**CITY OF MOUNTAIN VIEW
MEMORANDUM**

SUBJECT: MAY 25, 2010 STUDY SESSION—HIGH-SPEED RAIL ALTERNATIVES ANALYSIS

The purpose of this Study Session is to gain Council input on proposed comments from the City to the California High-Speed Rail Authority (CHSRA) on the Preliminary Alternatives Analysis Report (AA) for the High-Speed Rail (HSR) project.

DATE MAY 10, 2010

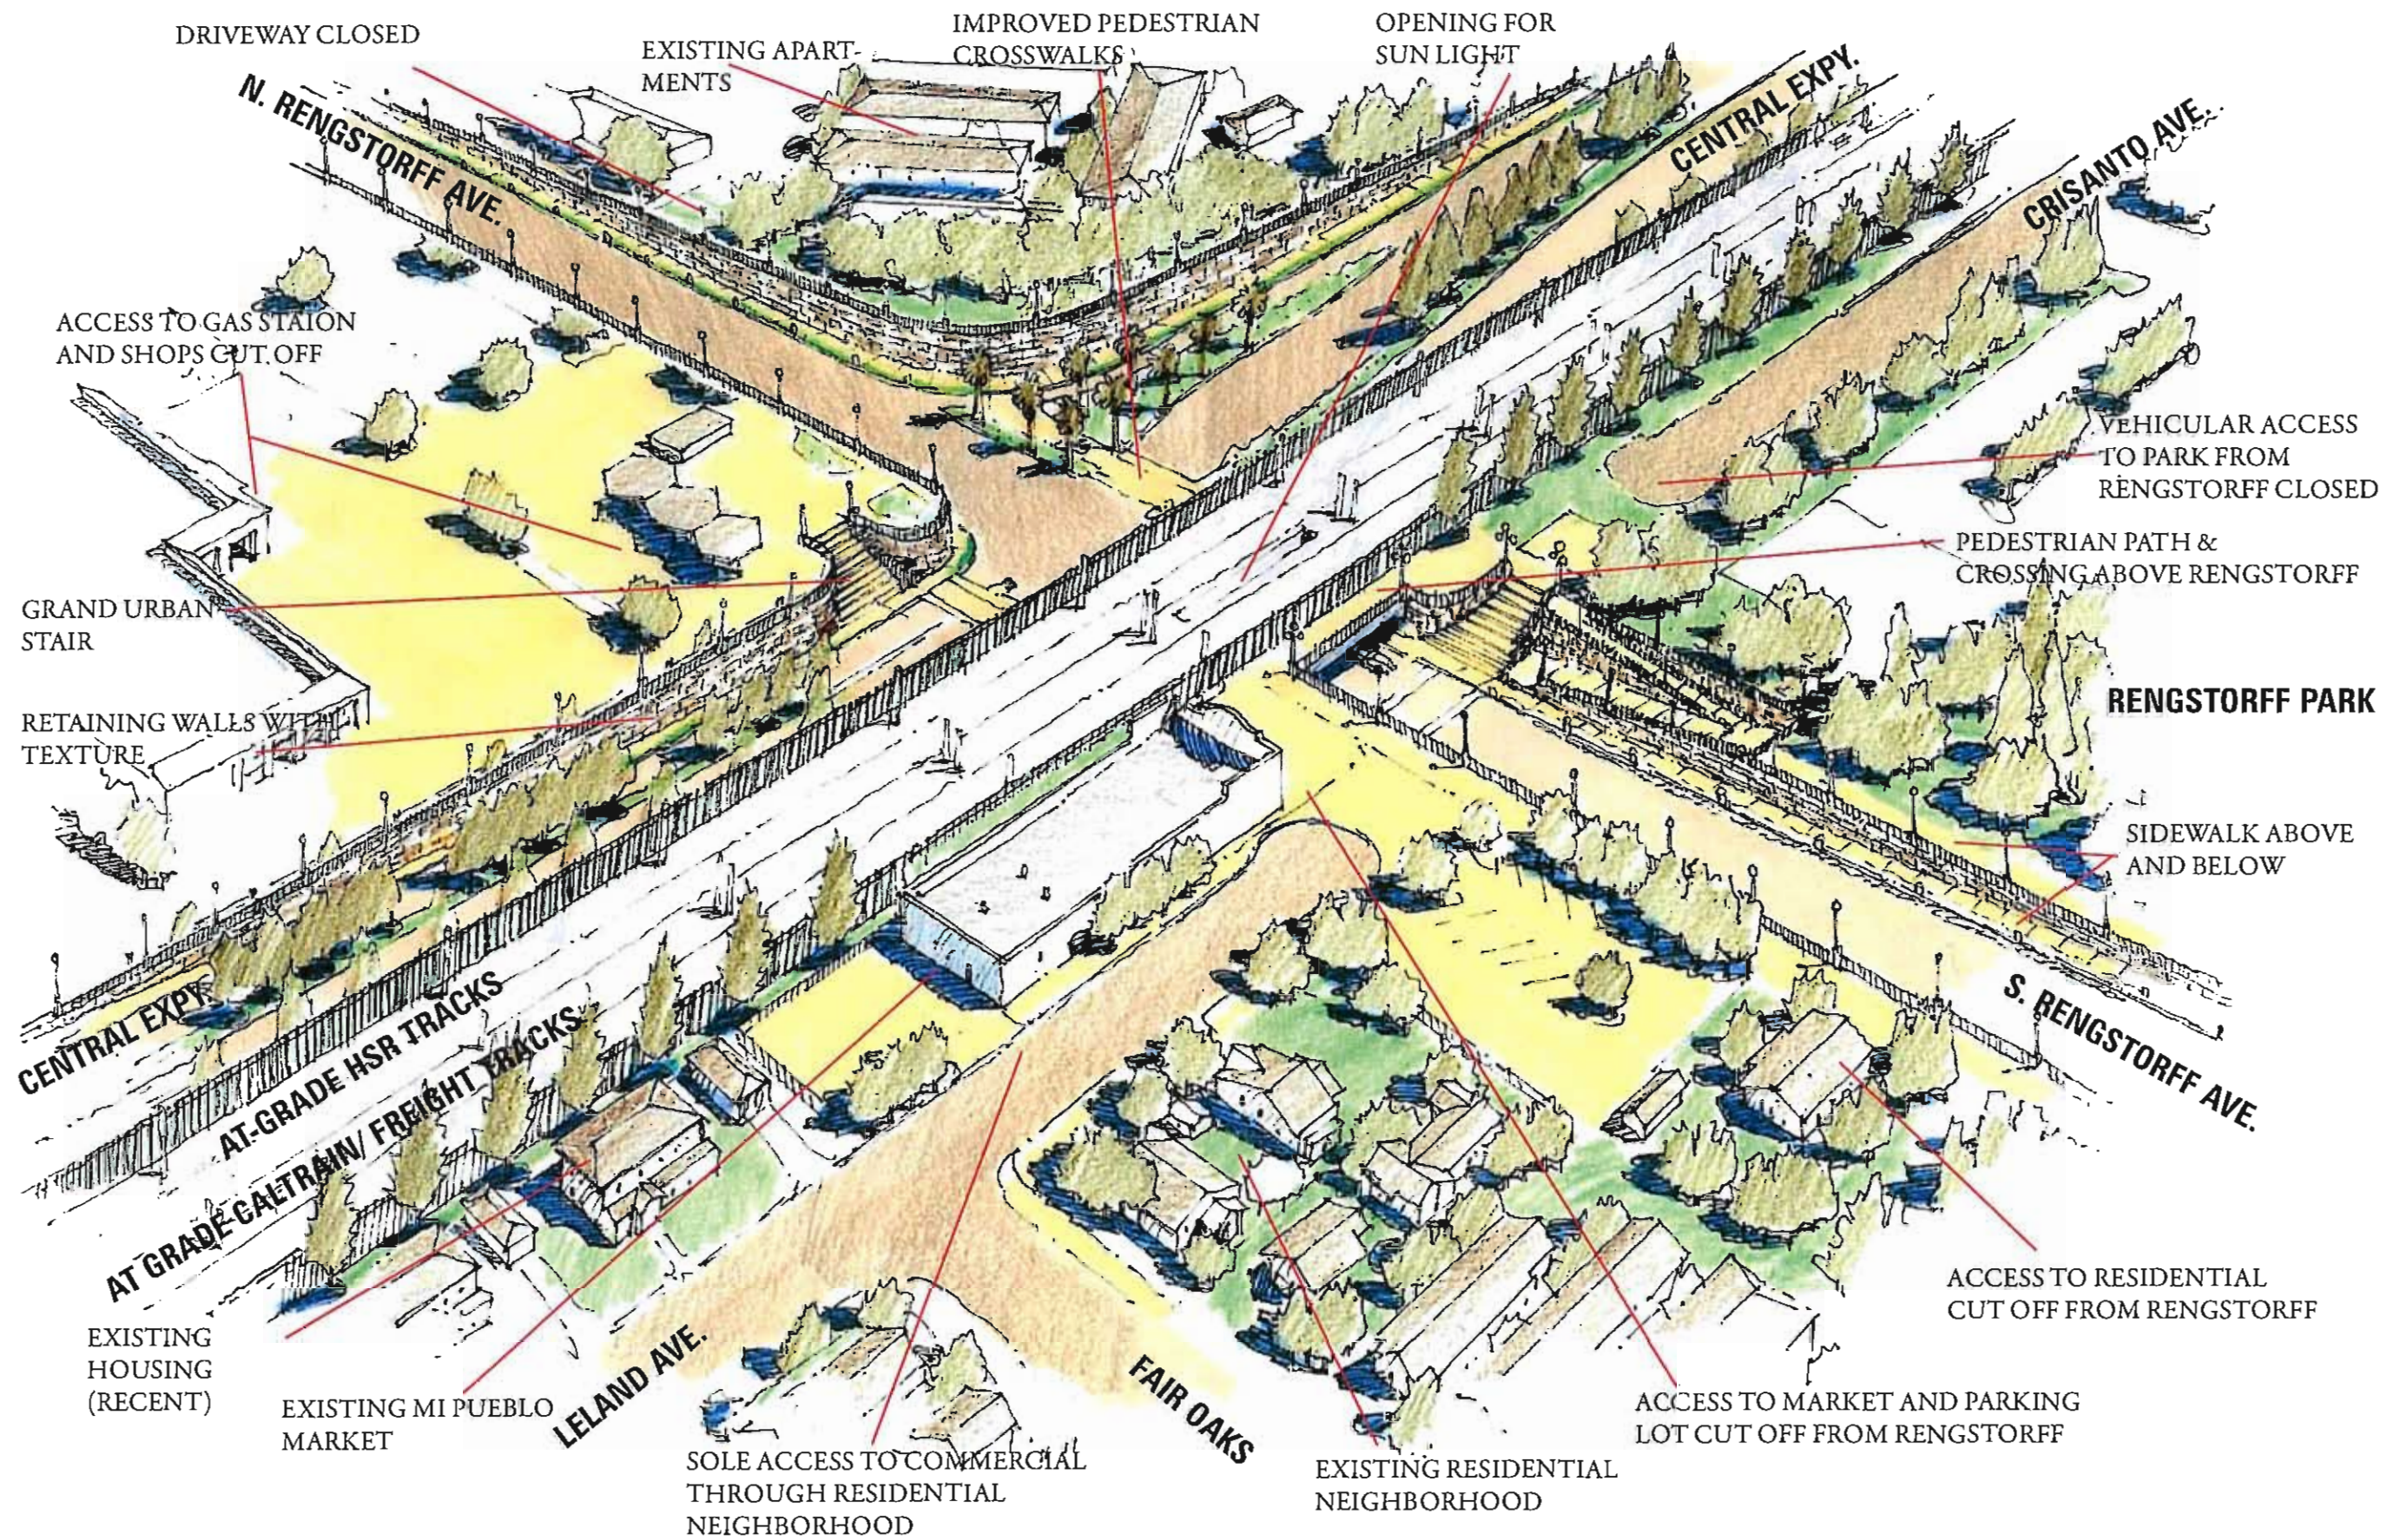
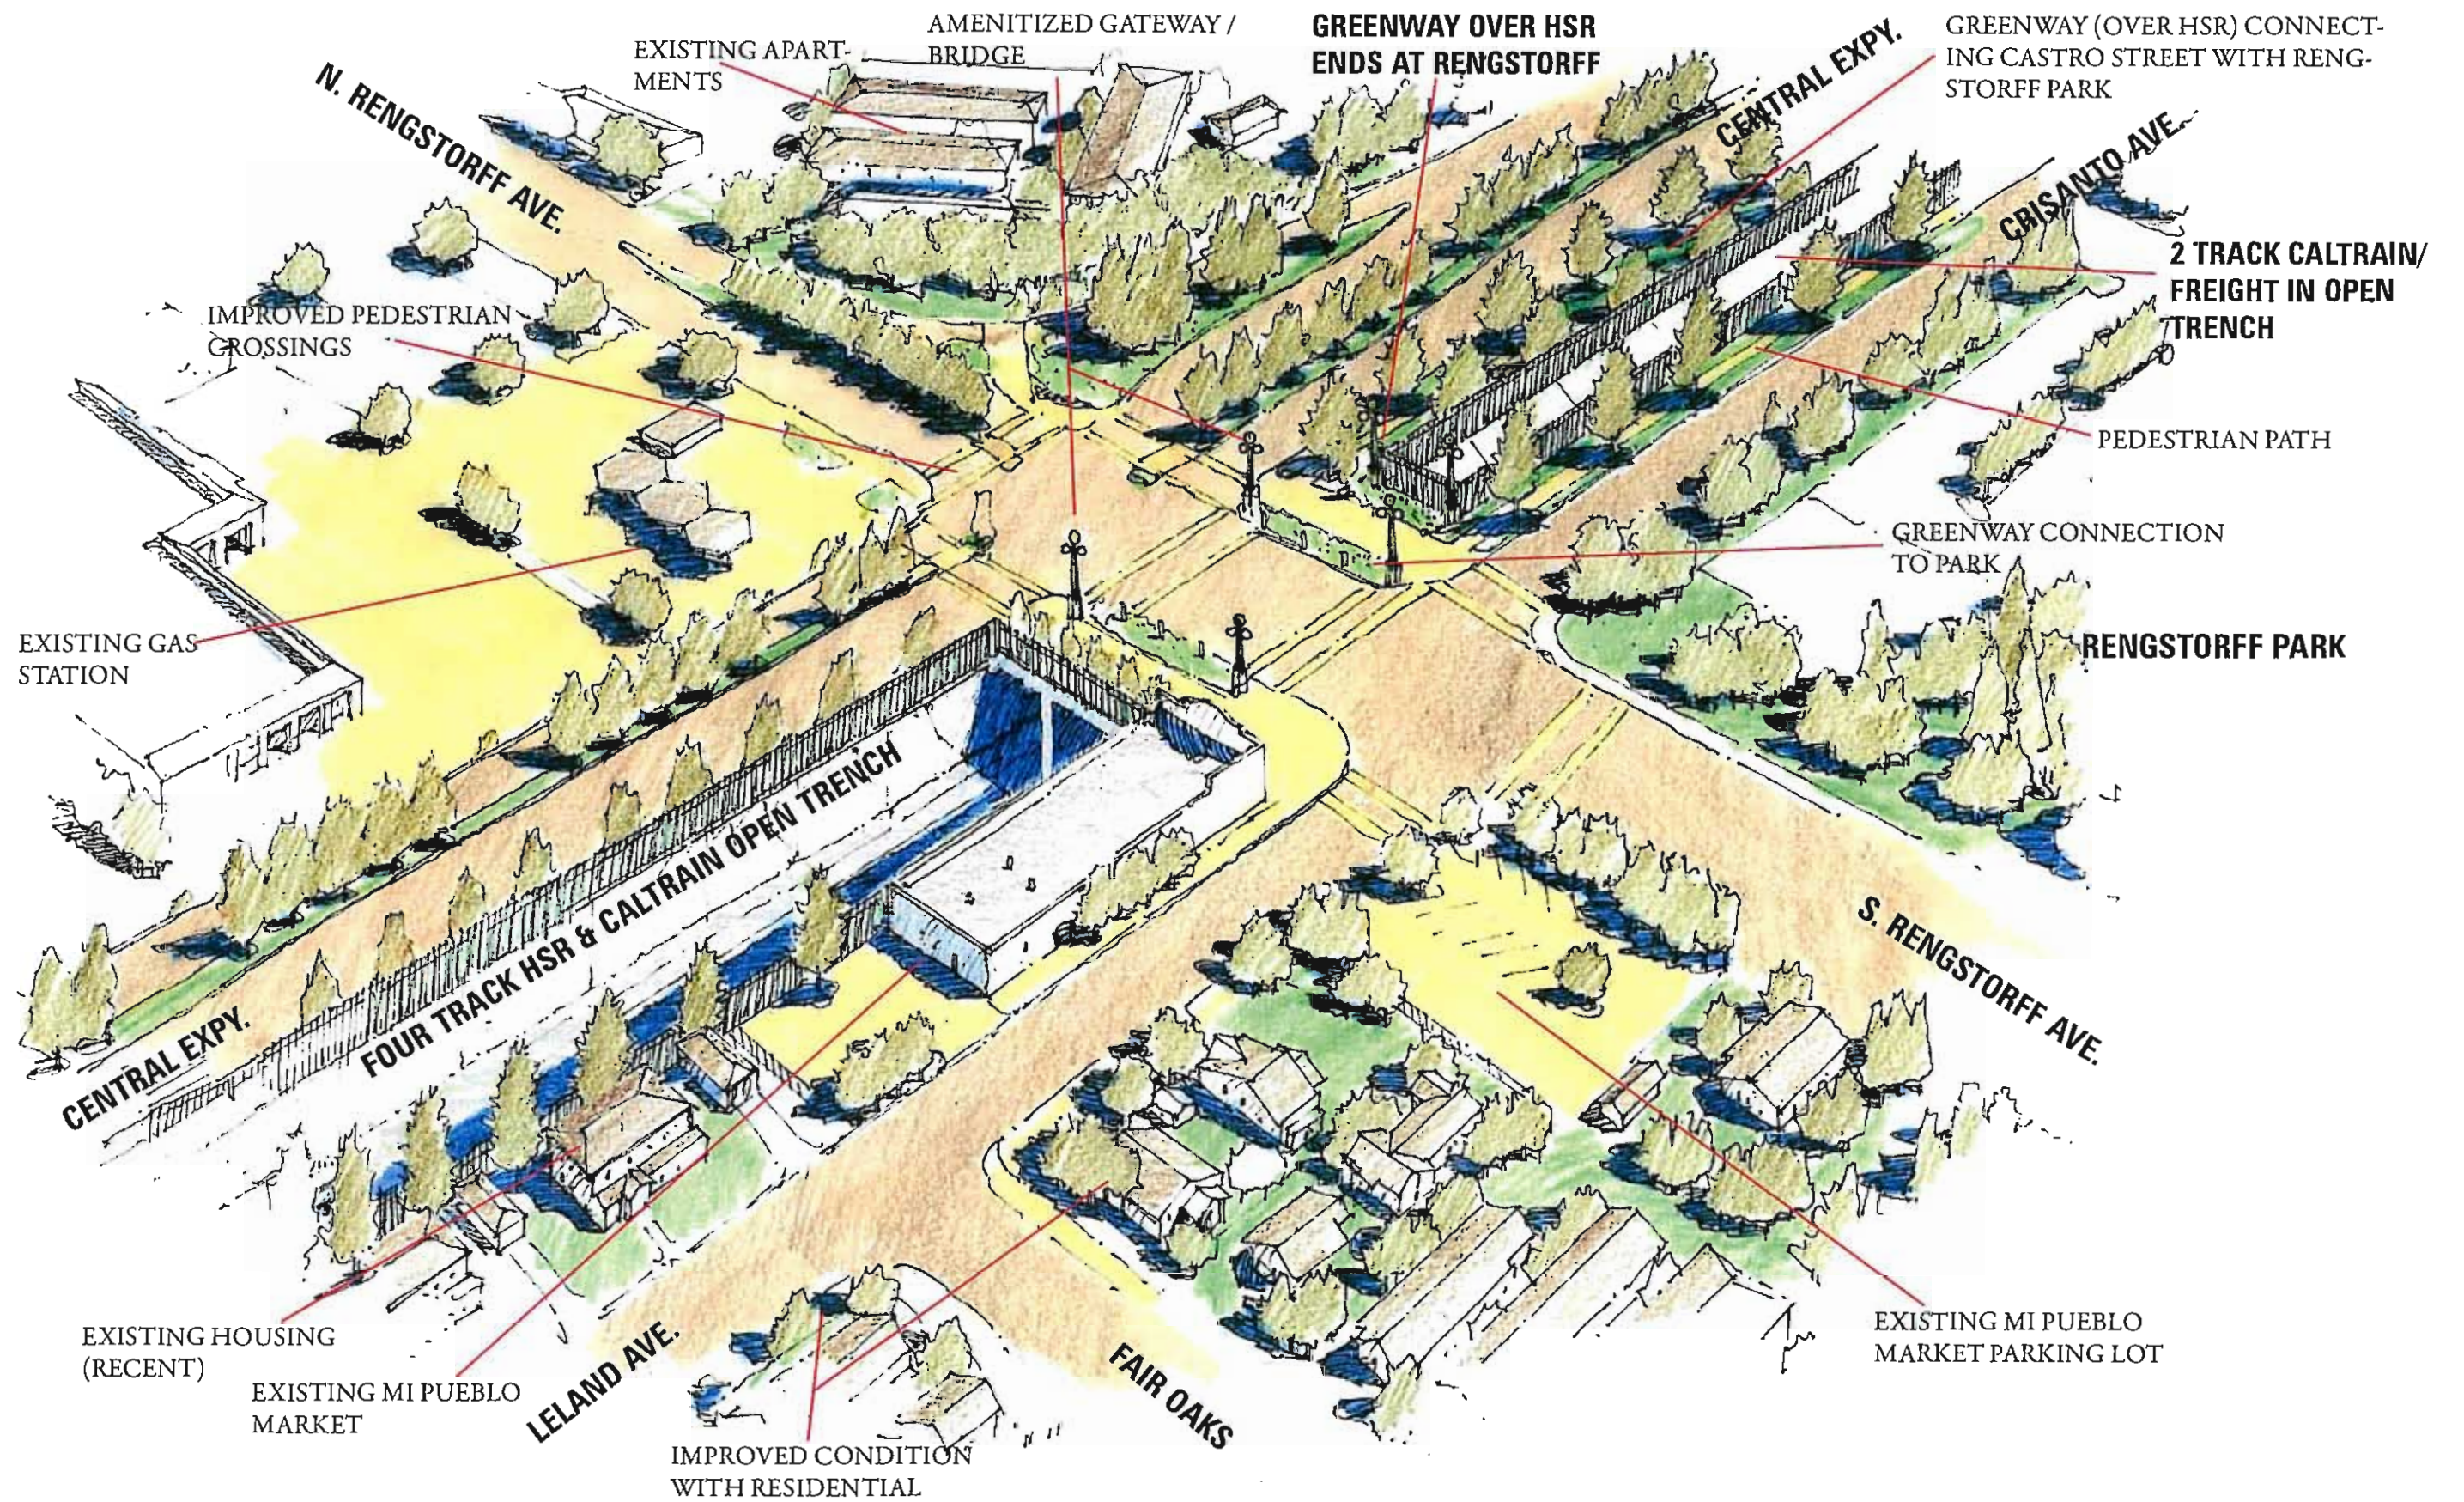
- The aerial viaduct has the greatest negative visual impact on the community. While very little information about the detailed design of an elevated structure was available in the AA, enough was provided to indicate that the size and scale of structure required to elevate the HSR/Caltrain/freight rails is akin to an elevated freeway structure bisecting the City and would dramatically change the view along the entire corridor. The FTS cross section of Castro Street with the aerial

structure in the background (see Attachment 3) shows the structure behind the train depot building at Centennial Plaza and gives an idea of the size and scale of the structure viewed from Castro Street.

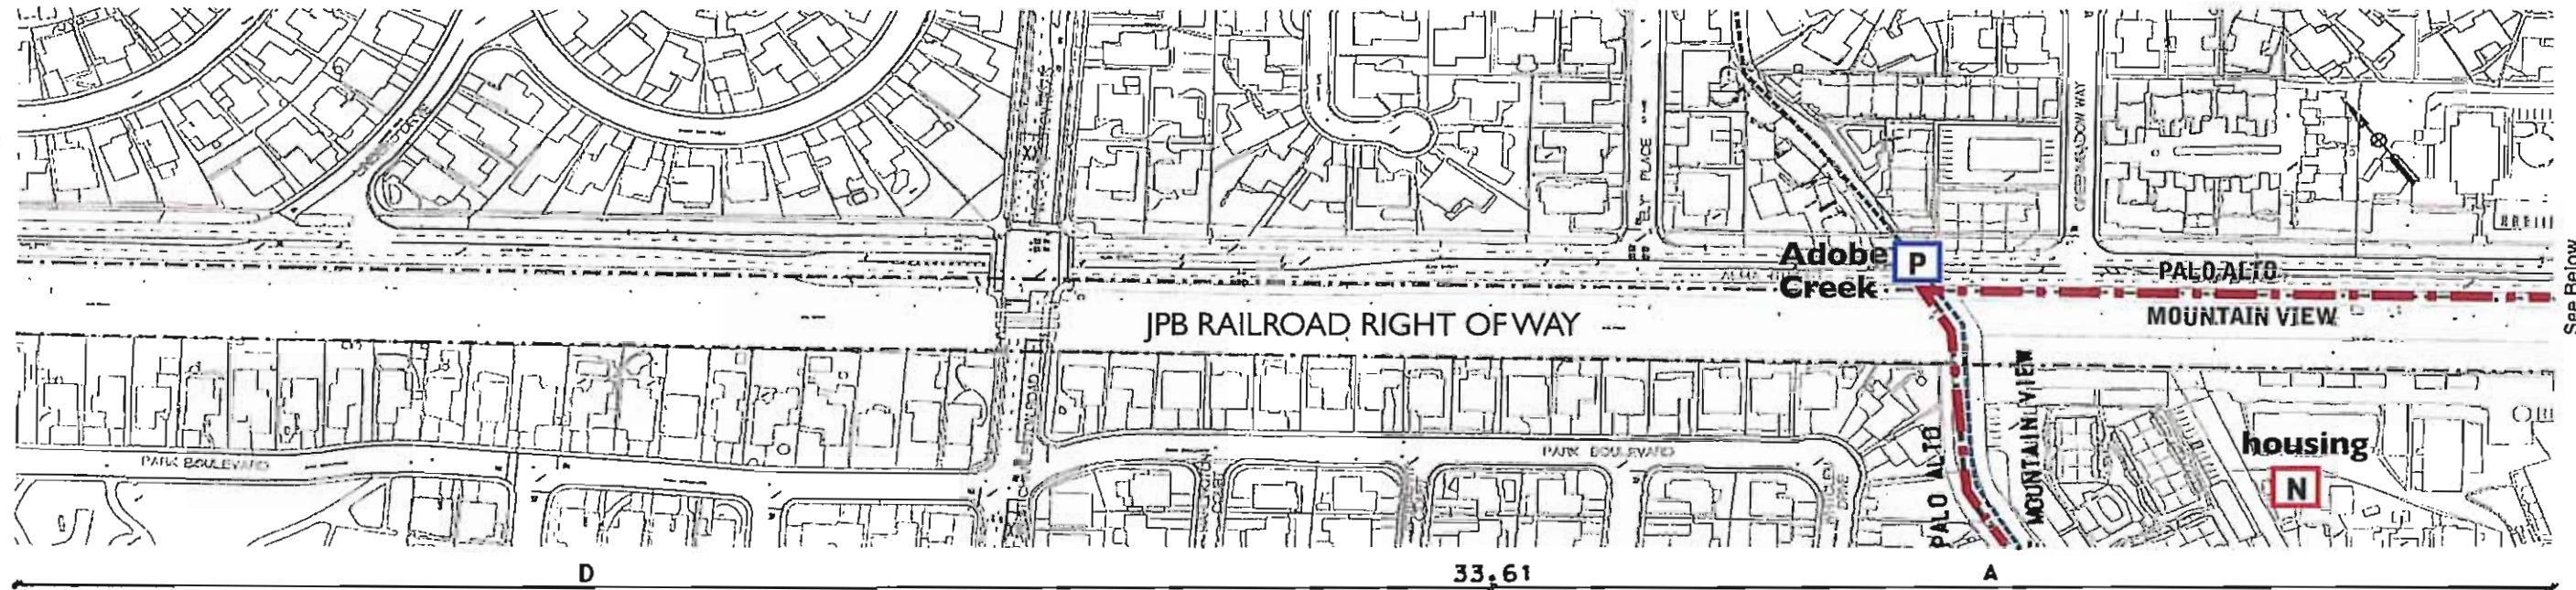
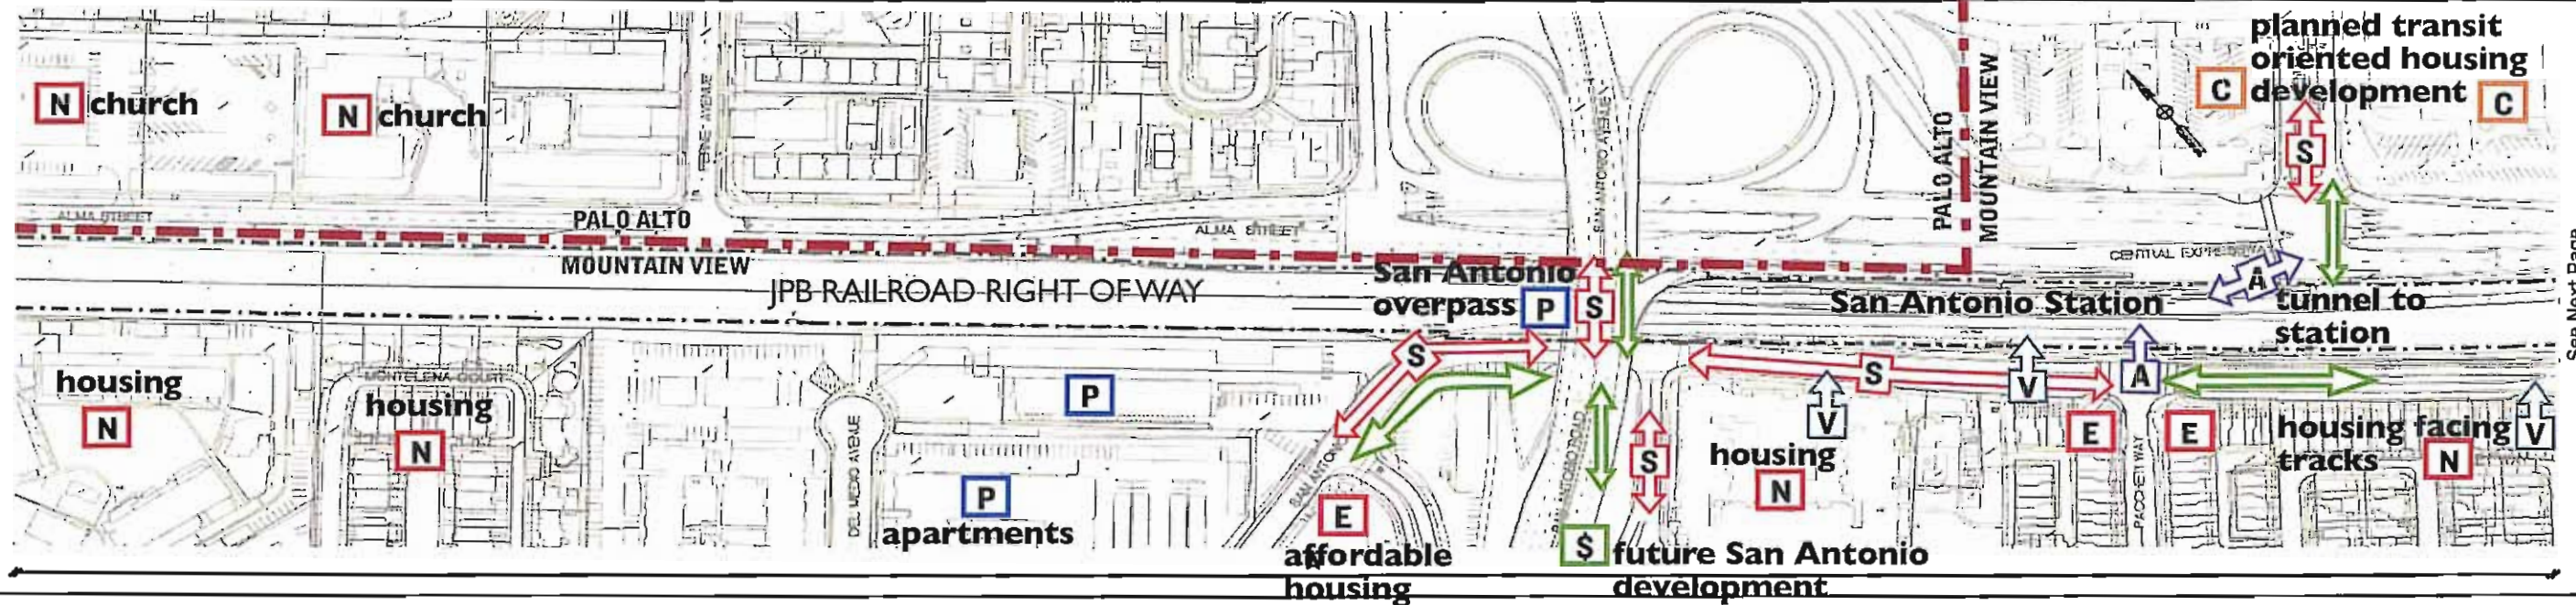
E: Minority businesses. Minimize impact.
S at Rengstorff: Improve safety for crossings as crossing is used by nearby schools and businesses.
Maintain cross connectivity at Rengstorff.
Provide east side access to the San Antonio platform.

- Maintain safety, station accessibility & connectivity to existing performing arts & future development of San Antonio & shopping center, existing neighbors along Showers Drive & Central Expressway.
- Maintain pedestrian/bicycle access tunnel at San Antonio Station. An extension of the pedestrian/bicycle underpass under Central Expressway to connect to new housing and neighborhood is planned.
